OWNER / DEVELOPER:
TARAHUMARA TRUCKING, LLC
14221 E 4TH AVE, SUITE 221
AURORA, CO 80011
JULIO HERRERA
720-638-1114
TARAHUMARATRUCKINGLLC@GMAIL.COM

TARAHUMARA SUBDIVISION FILING NO. 1

COVER SHEET
2260 ANDES WAY

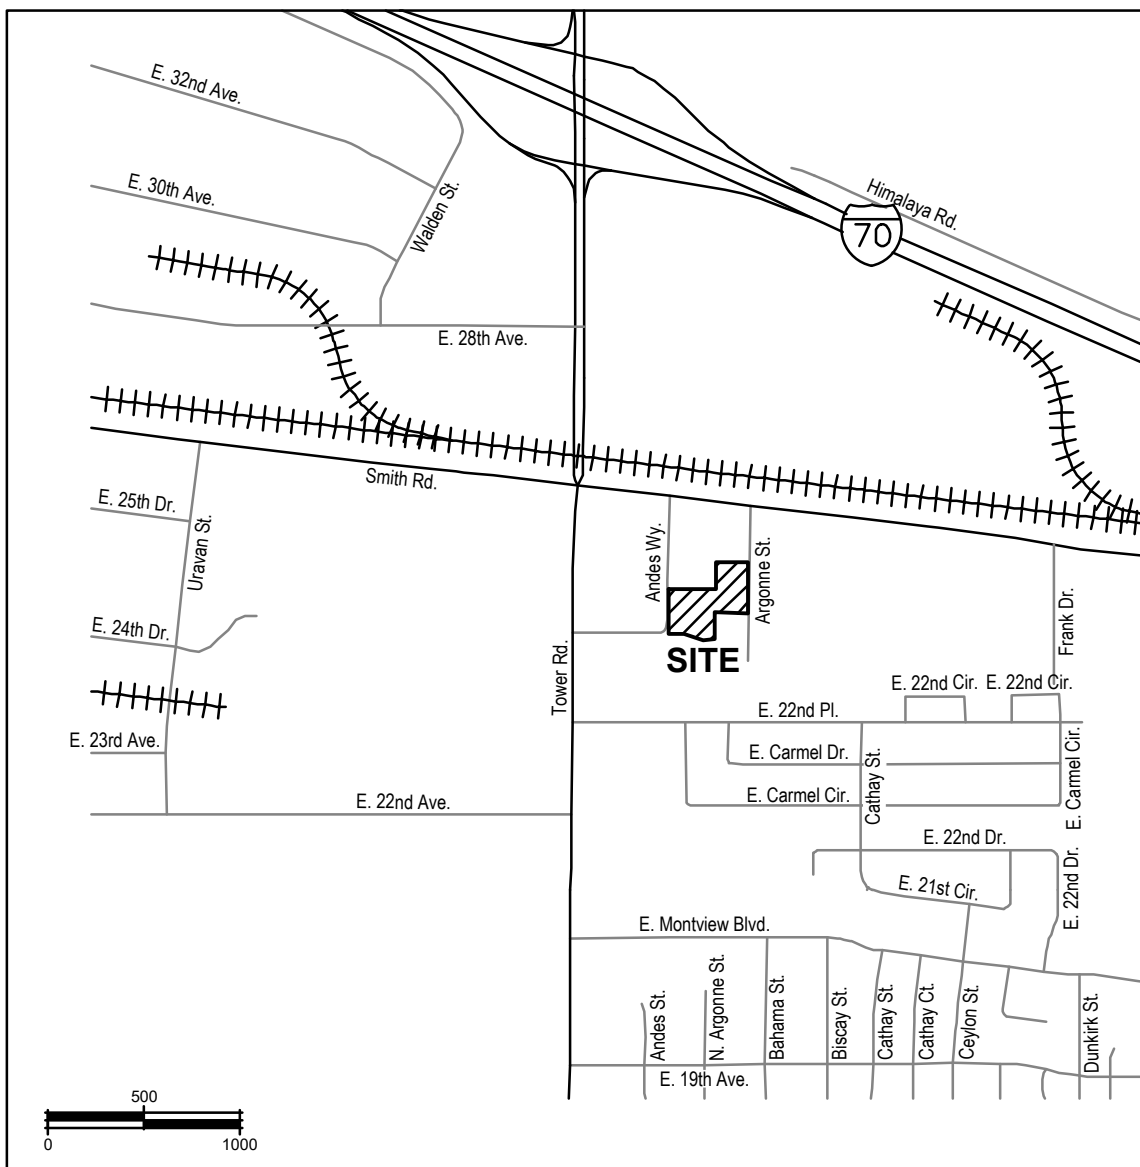
Title the site plan “Tarahumara Trucking-Site Plan”.

Please delete
crossed out
portion

This sentence is a repeat of the previous sentence. Remove but keep the other one.

The site plan will not be approved by Aurora Water until the preliminary drainage letter/report is approved.

SHEET NO
2 OF 13

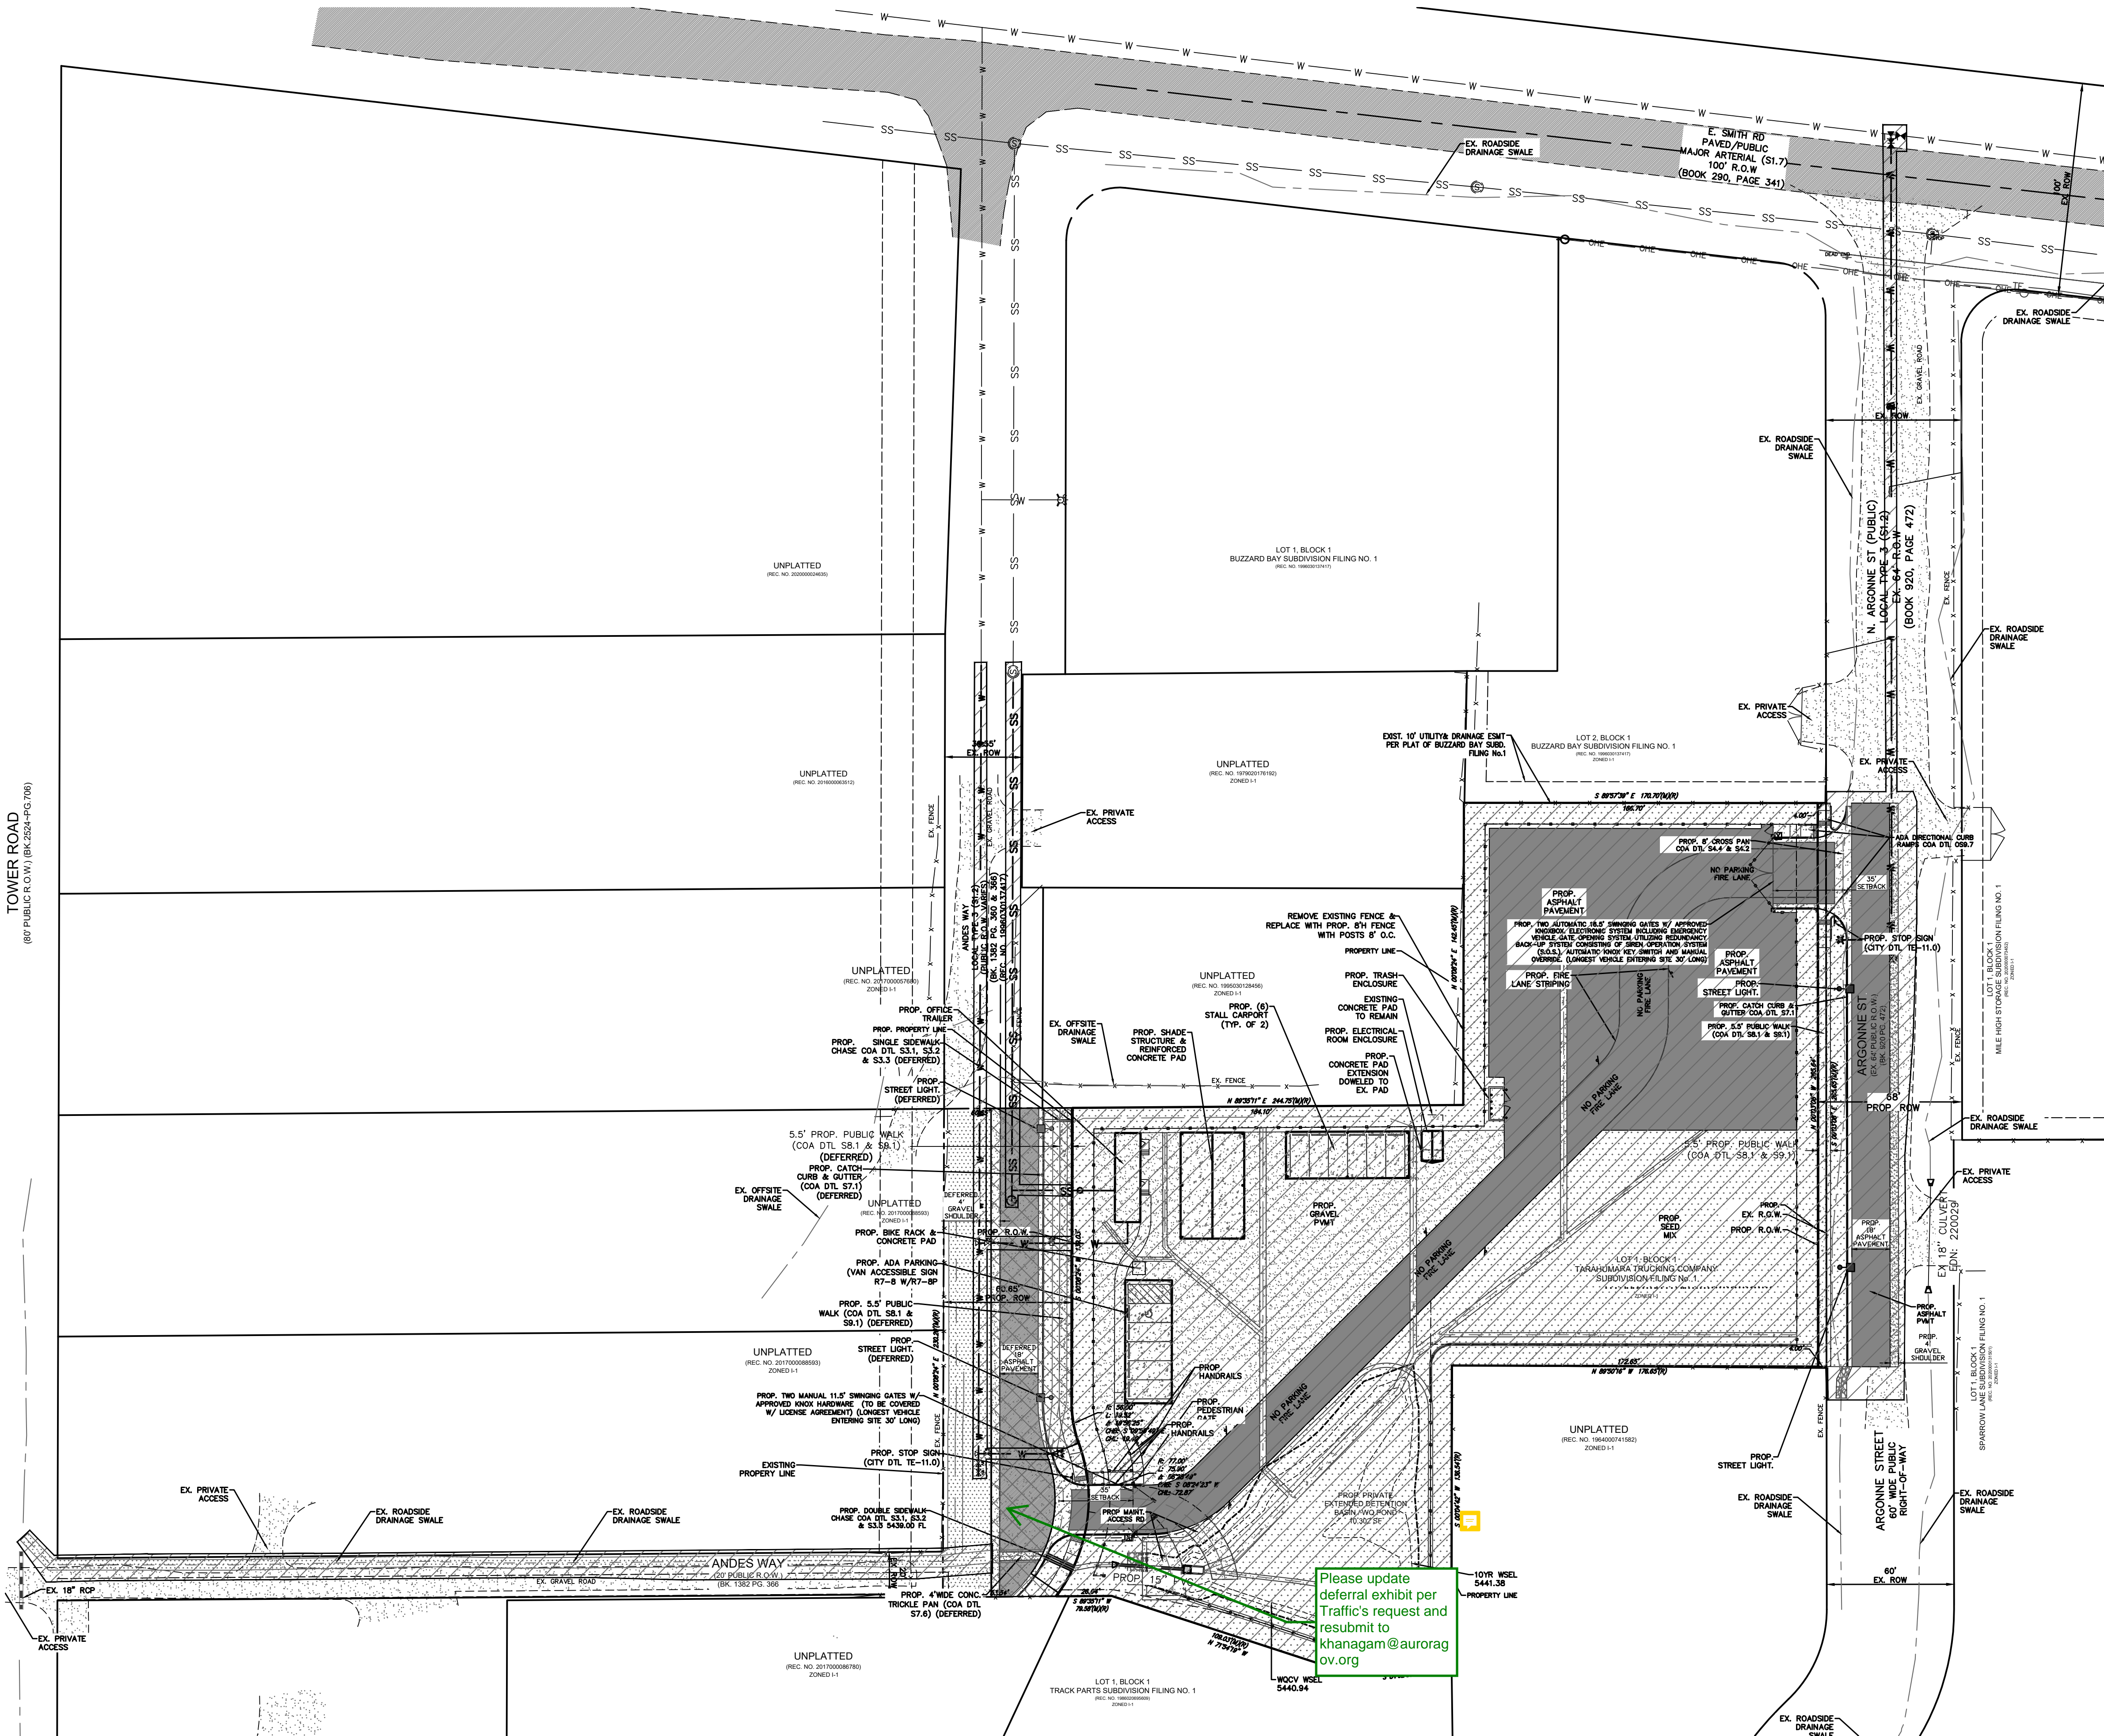
This access will need to be aligned with access on the other sides of Argonne St. The other choice is to move the access a min of 75' south and be between the two accesses on the east. Access needs to be a minimum of 75' from other accesses for safety.

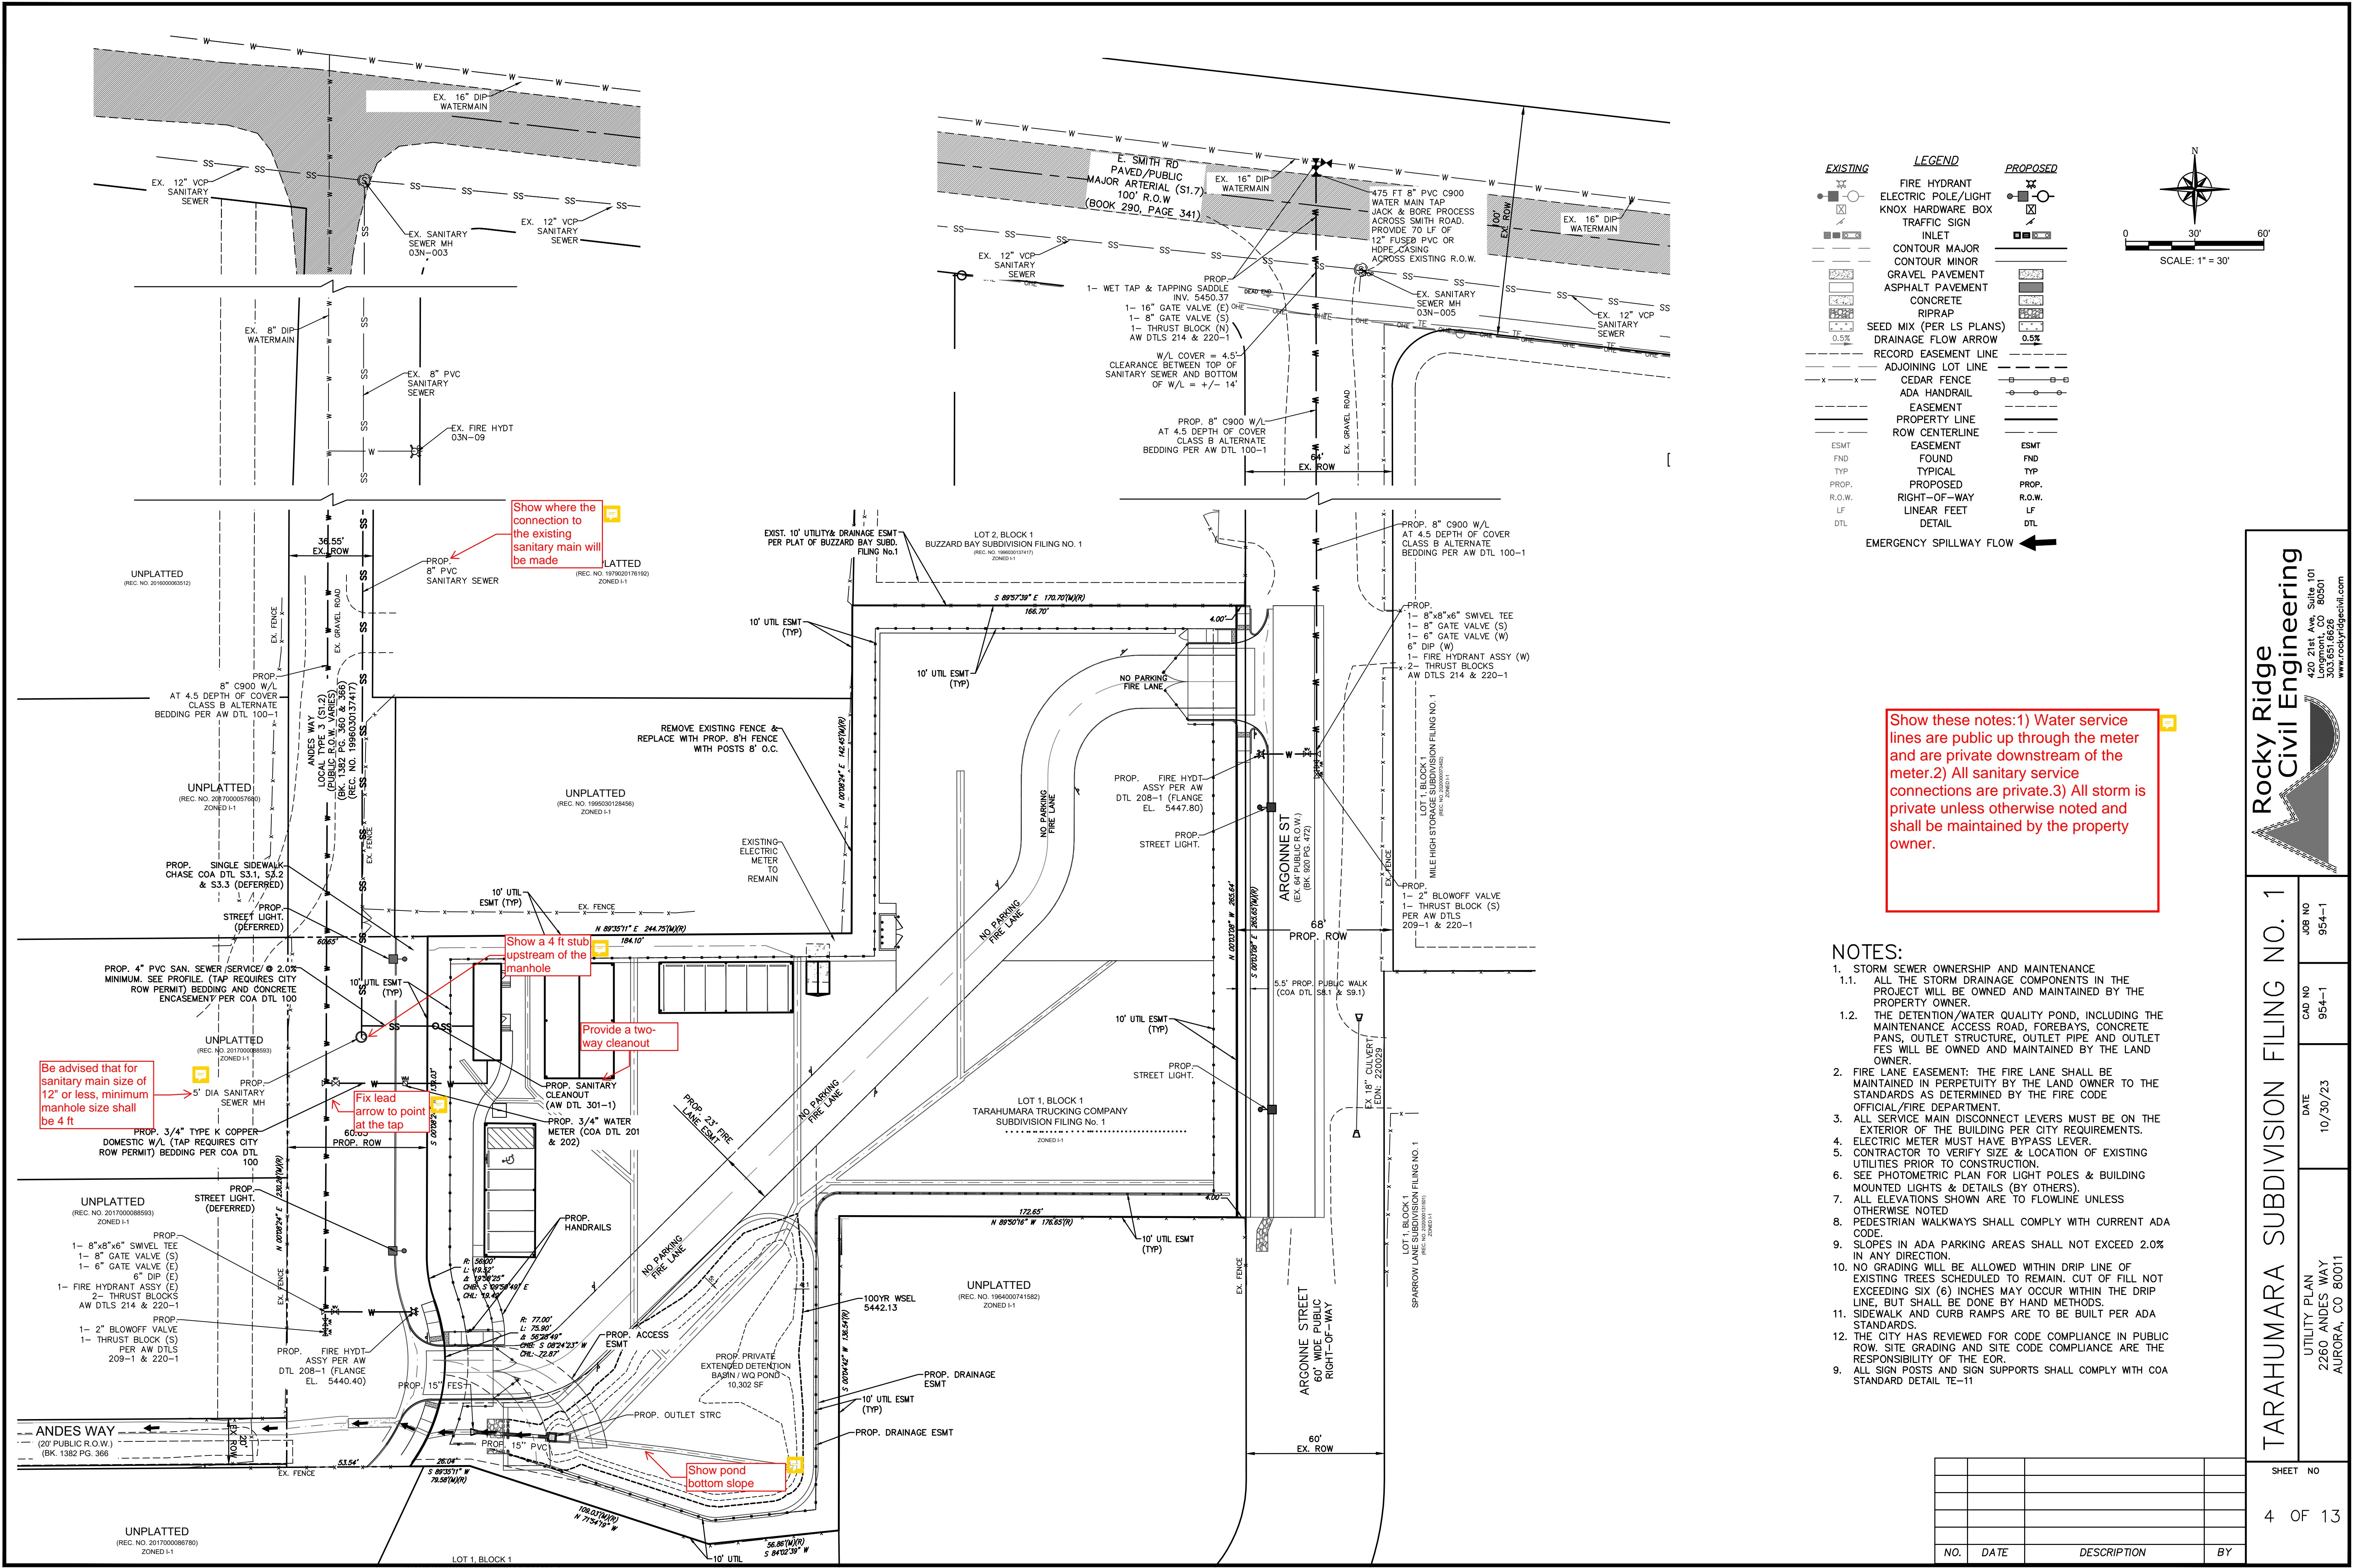
Show revisions on this site plan per comments on the preliminary drainage report and plan (TYP)
